**MINUTES**  
**WORCESTER TOWNSHIP PLANNING COMMISSION**  
**WORCESTER TOWNSHIP COMMUNITY HALL**  
**1031 VALLEY FORGE ROAD, WORCESTER, PA 19490**  
**THURSDAY, DECEMBER 14, 2023 - 7:00 PM**

Reference: BT Worcester, LLC – City View Land Development  
Preliminary Plan Review – Third Review

RE: **Traffic Review #5 – Highway Occupancy Permit Plans (PennDOT & County)**  
City View (formerly Fairview) Apartments (2974 W. Germantown Pike) – 180 proposed apartment units  
Worcester Township, Montgomery County, PA  
Project No. 310767-01-001 (formerly 821A37.11)

BT WORCESTER, LLC  
 CITY VIEW - APN #67-00-01606-001  
 2974 GERMANTOWN PIKE, WORCESTER TOWNSHIP,  
 MONTGOMERY COUNTY, COMMONWEALTH OF PENNSYLVANIA  
**STORM SEWER PROFILES**

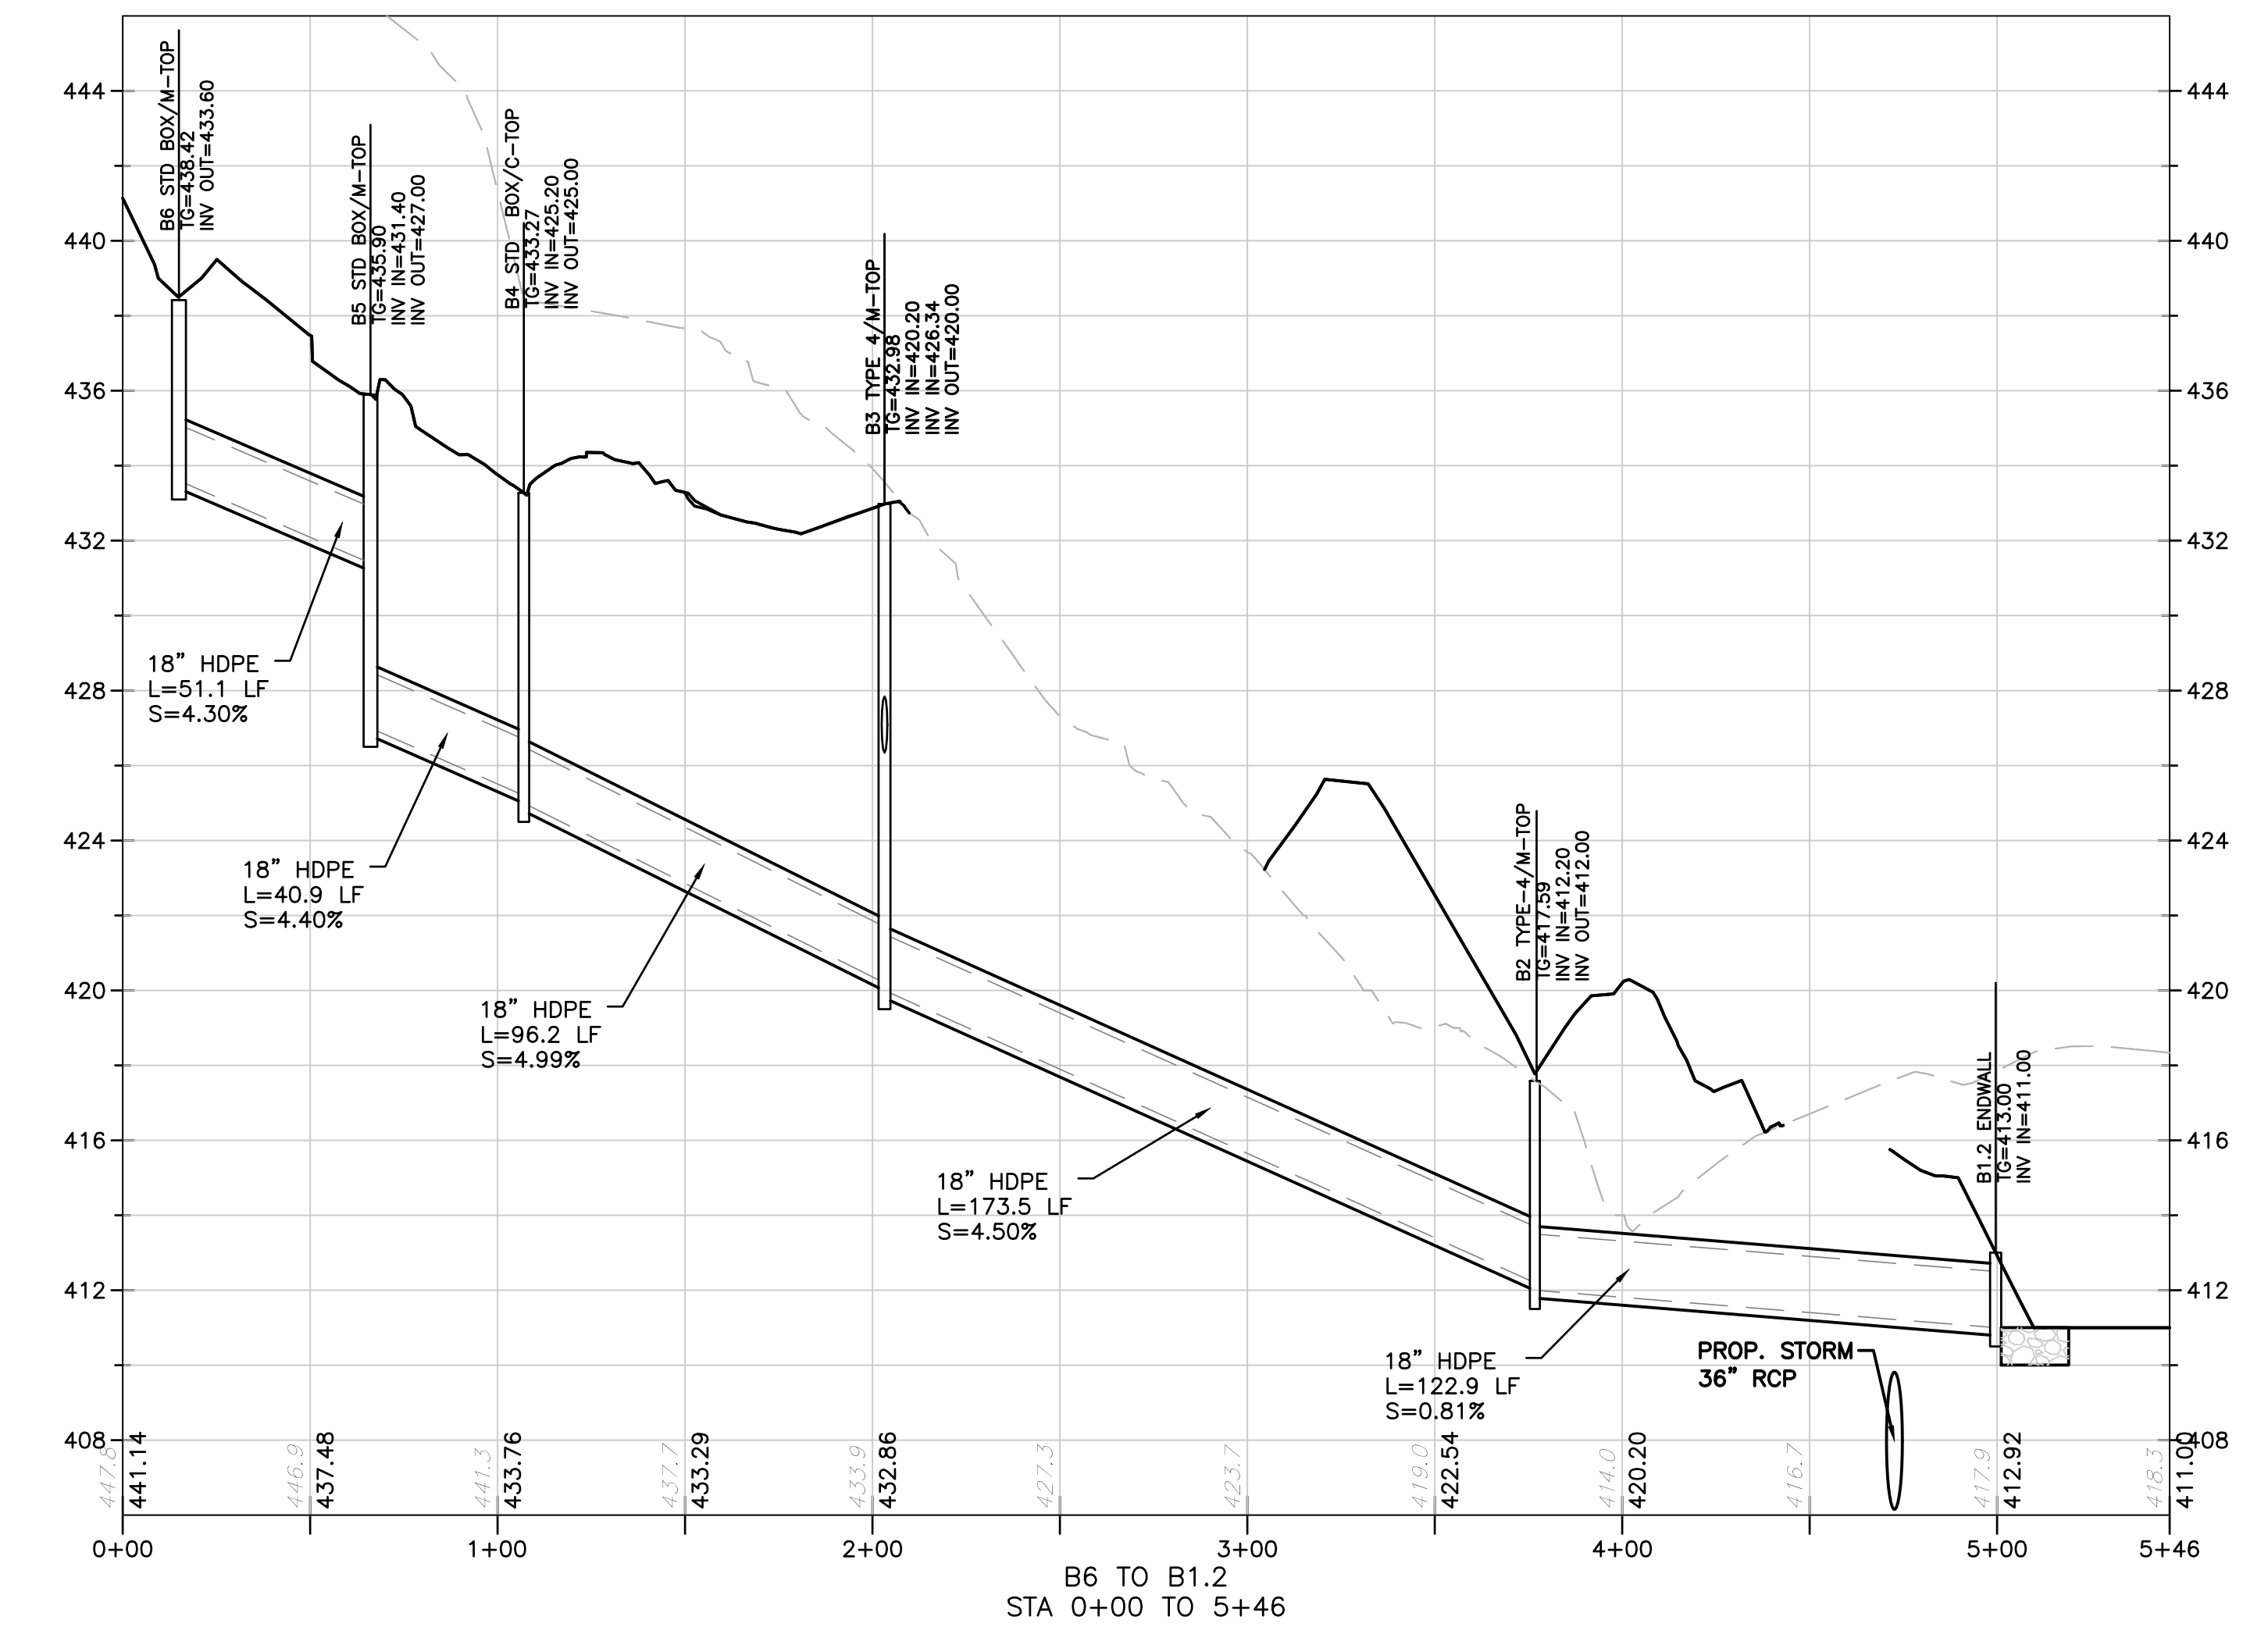
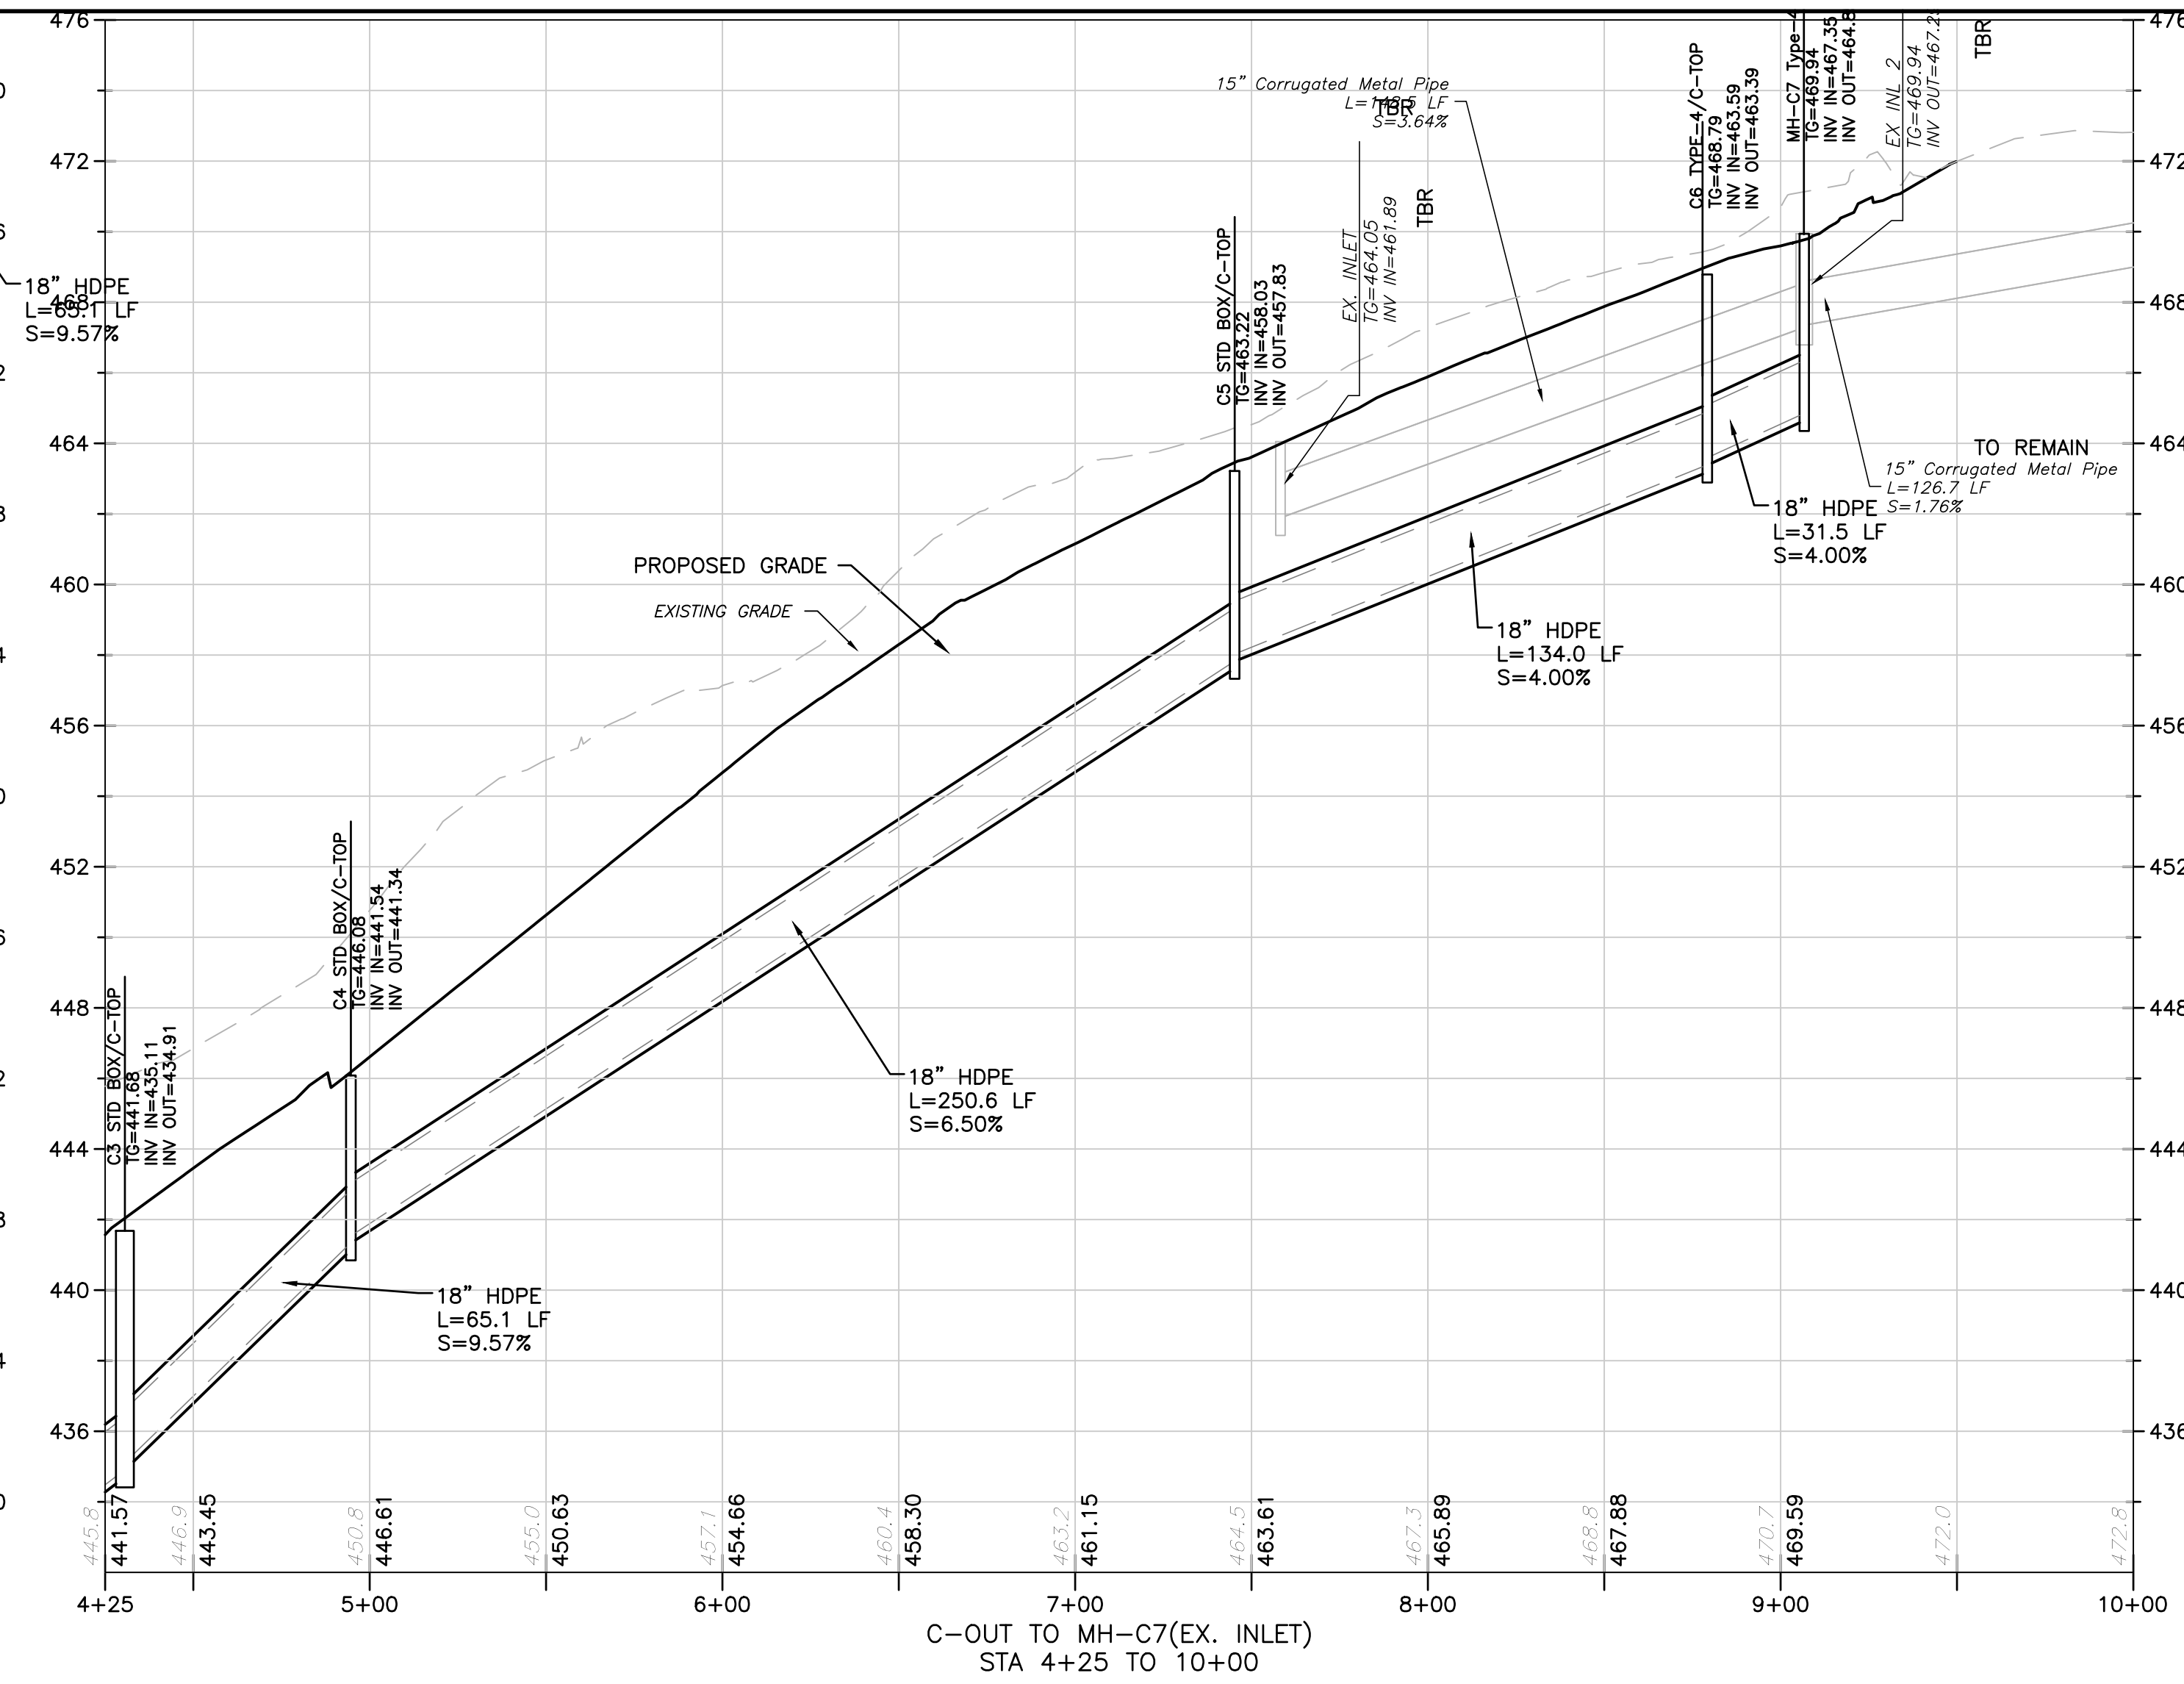
30. A profile of storm sewer B 003 to MH-B1 must be added to the plans.
31. All portions of the basin bottom shall have a minimum slope of 2%. The proposed Basin B appears bottom is flat. The applicant's response states that a waiver will be requested. SMO 129-18.H(10)).
32. A stabilized access drive with an access easement has been shown for Basin B. The engineer's response that indicates Grass Pave Turf Reinforcement has been called out on the plans. This office cannot find this plan reference for the Basin Access Drive. (SMO 129-18-H(22)).
